SB, New Handles, DM220, 2022-06

SYMPTOM/DESCRIPTION

Figure 1: New Trigger-Lock Bracket installed.

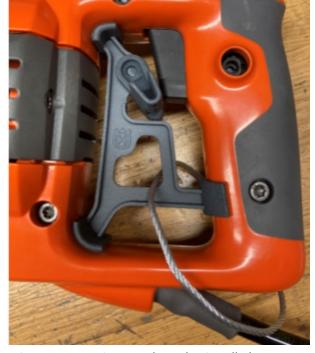
Due to compliance regulations, we have changed the handle halves on the DM220 and removed the lockon button. This button is replaced by a trigger lock bracket which can be placed inside the handle (see figure 1).

To use the trigger lock bracket, simply insert it into the handle and rotate the lever to hold the trigger pushed in.
